Process Sheet

Customer : CU-DAR001 Dart Helicopters Services	Drawing Name : AFT TUBE ASSEMBLY
Job Number : 33846	
Estimate Number : 10699	
P.O. Number : <i>NA</i>	Part Number : D3391025
This Issue : 8/8/2007	Drawing Number : D3391 UNDER REVIEW
Prsht Rev. : NC	Project Number : N/A
First Issue : <i>NA</i>	Drawing Revision : F
Previous Run : 33648	Material : <i>NA</i>
Written By : <i>JLM 07-08-08</i>	Due Date : 8/15/2007
Checked & Approved By :	Qty: <i>4</i> Um: Each
Comment : Est Rev B 06-02-07 ECN773 dwg rev. D EC	
Est Rev C 06-03-28 Update Manufacturing Instructions	
JLM	
est rev D 07.03.20 revF dwg ec

From: David Shepherd [dshepherd@dartaero.com]
Sent: August 29, 2007 6:33 PM
To: 'Peter Hum'
Subject: RE: D3391-5 aft tube taper deviation

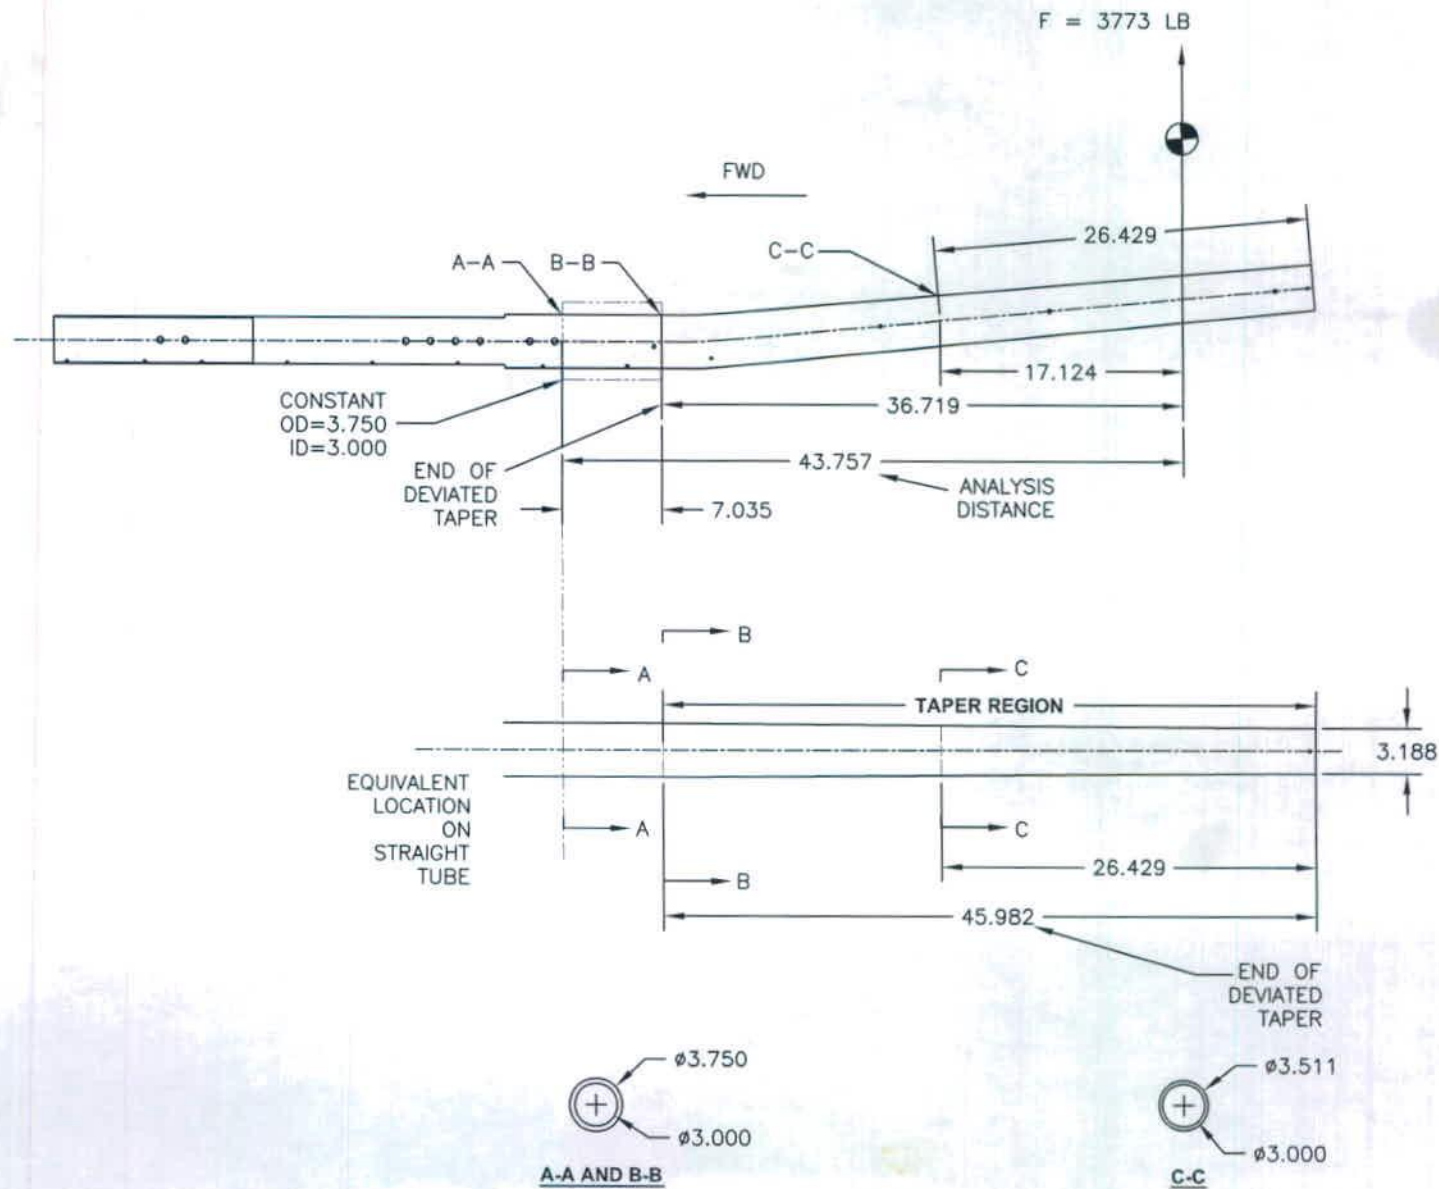
- a) The approved analysis we have only takes the section immediately aft of the aft saddle. This is donated by Section A-A in the attached sketch.
- b) I took analysis at Section B-B (start of taper) and C-C (mid point of taper) and have shown that these have increasing positive margins. These sections ARE NOT in the approved analysis. I think this would be easier since I can't take analysis at every location on the taper.

I am showing that despite the change in taper, positive margins still exist throughout the skidtube.

I can't tell from what you present in the email if the tube is OK or not.
Do we still have a positive margin of safety everywhere based on our approved analysis?
It might be better to calculate new margins at critical sections in addition to your generalized argument.

Manufacturing is machining a D3391-5 aft tube. The material had chatter marks from the machine. In order to

blend out the chatter marks; the machinist removed more material and extended the taper in order to blend it in to the straight section.

The analysis we have for this area of skidtube is for a point just aft of the aft saddle 43.754". The dimensions are OD=3.750", ID=3.000". Since the taper ends 7.00" AFT of the analysis point the moment will be less here.

The attached analysis shows that the Moment ($F \cdot d$) decreases FASTER than the decrease of Moment of Inertia (I).

I performed analysis with the deviated taper and it shows that the moment decreases as we go down the taper toward the center of buoyancy of the aft bag; the Moment gets smaller as distance from center of buoyancy gets smaller.

Is this deviation acceptable?

AT A-A

STRESS = MC/I
 $M = 3773 \times 43.757$
 $C = D/2 = 3.75/2 = 1.875$
 $I = 5.731$
 STRESS = 54018
 YIELD STRENGTH = 57000
 $MARGIN = (57000/54018) - 1$
 MARGIN = 0.06

AT B-B

STRESS = 45326
 YIELD STRENGTH = 57000
 $MARGIN = (57000/45326) - 1$
 MARGIN = 0.26

AT C-C

STRESS = 32599
 YIELD STRENGTH = 57000
 $MARGIN = (57000/32599) - 1$
 MARGIN = 0.75

Based on your analysis, I think the deviation is acceptable.
